ADDENDUM No. One (1)

IFB No. 2019-084

CONSTRUCTION, COLLIN COUNTY JUSTICE CENTER, REPLACEMENT OF CHILLED WATER ACTUATORS AND VALVES

DATE: JANUARY 25, 2019

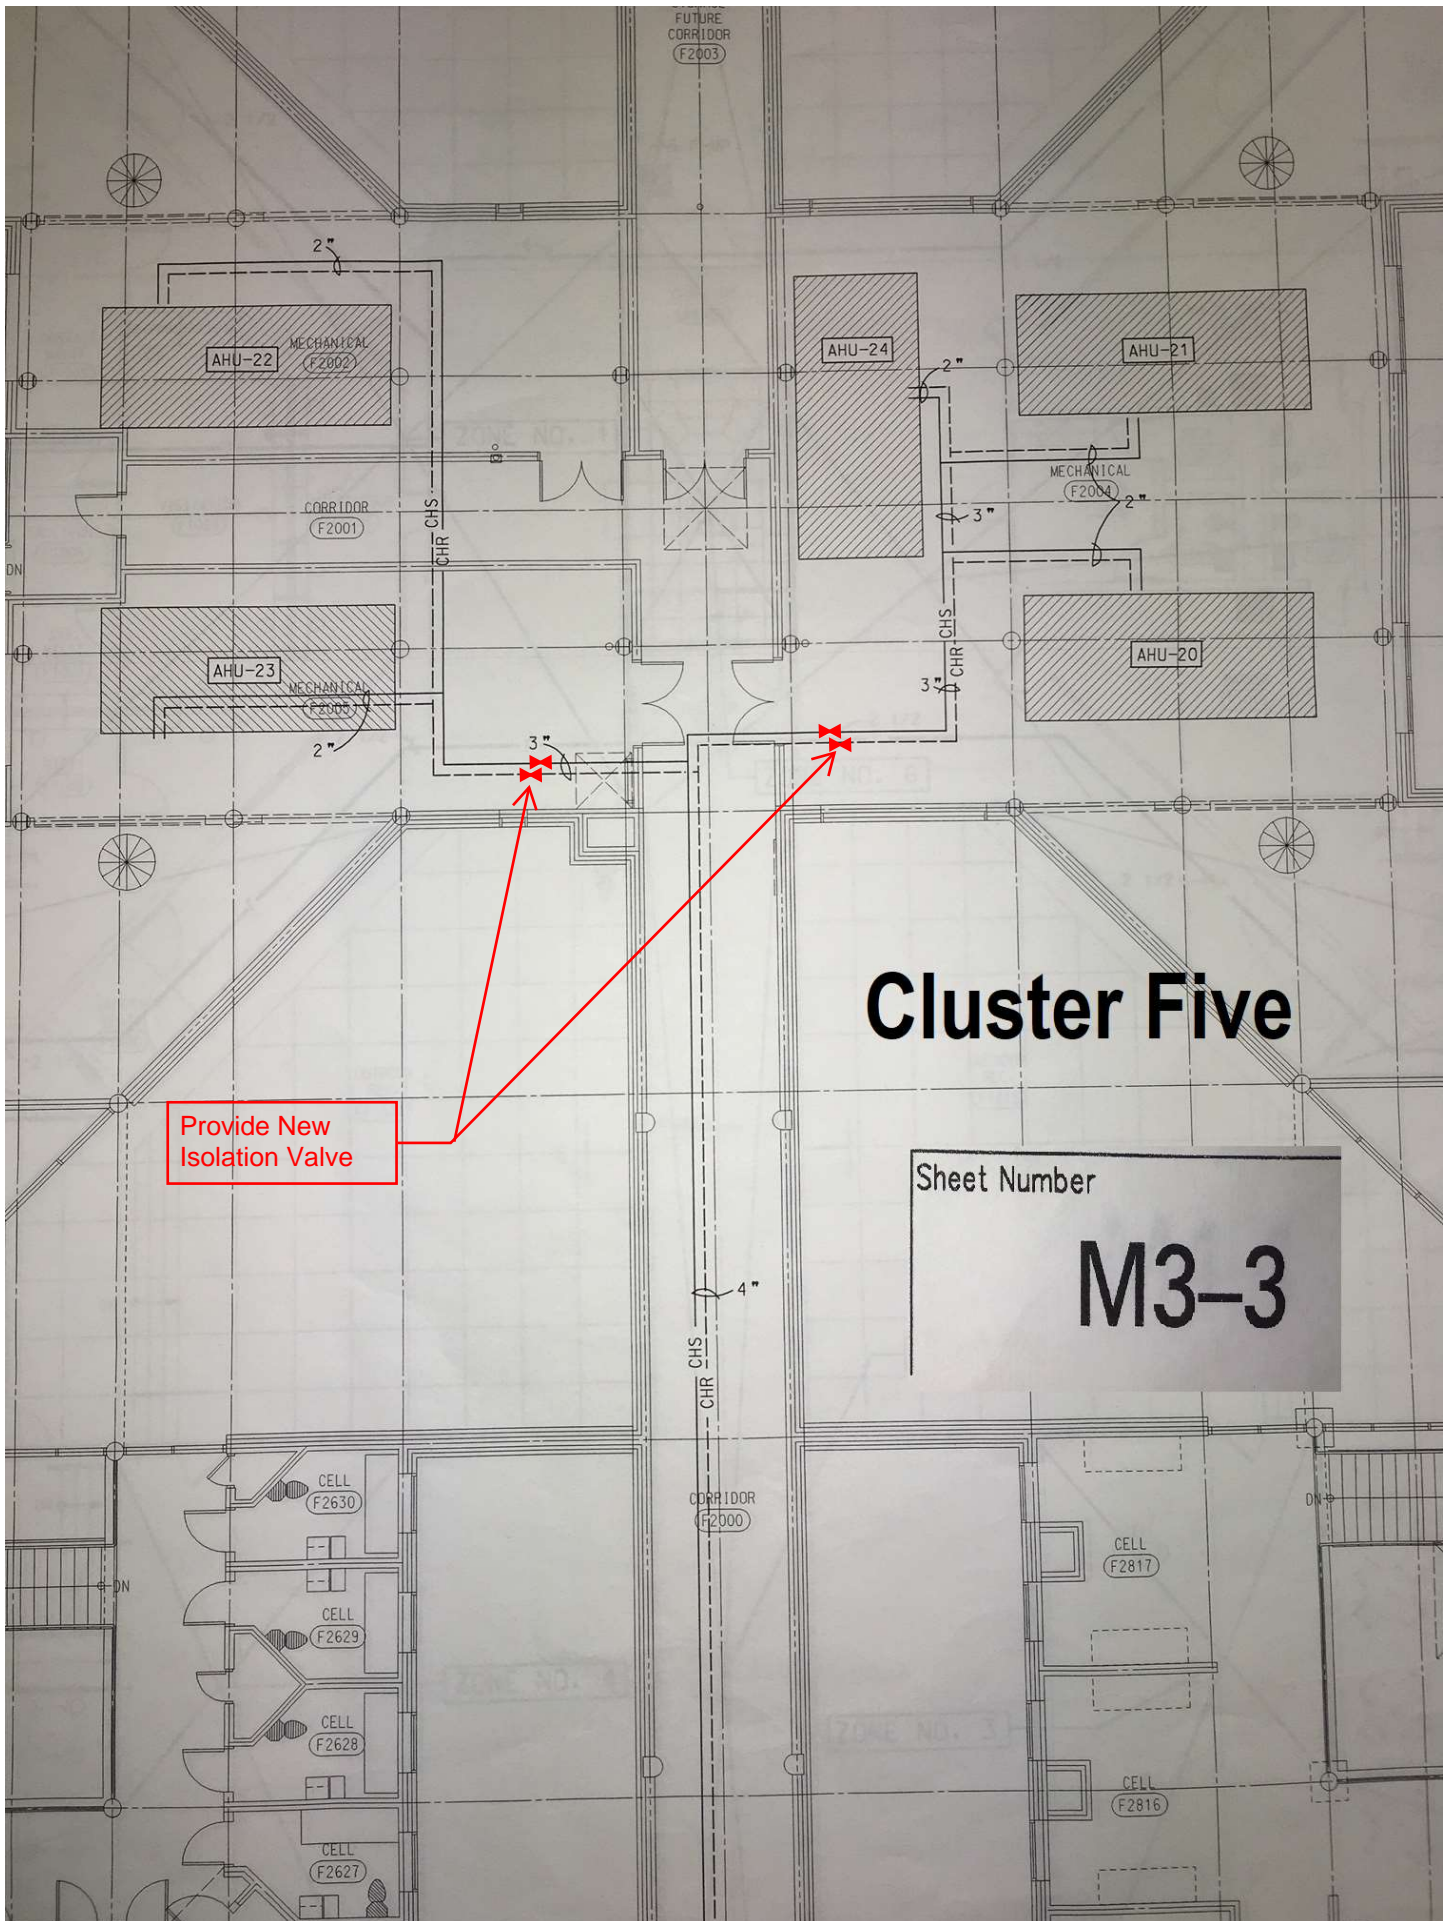
- 8.) Adding shutoff valves, type, locations and freeze method to install:

The contractor shall plan on installing new shut off valves in the mechanical rooms (to allow for isolation of groups of air handlers). The mechanical rooms that require the addition of isolation valves are indicated on the sketches provided (Refer to Attachment B). All other mechanical rooms have isolation valves outside the mechanical rooms or positioned to isolate the mechanical rooms/air handling units. It is understood that this will require nitrogen pipe freeze at a total of six locations of 3" pipe for the installation of a total of twelve (12) 3" butterfly valves for cluster 1, 3, and 5. Final location of the valves will be require coordination and be agreed to with Collin County facilities

Provide New Isolation Valve
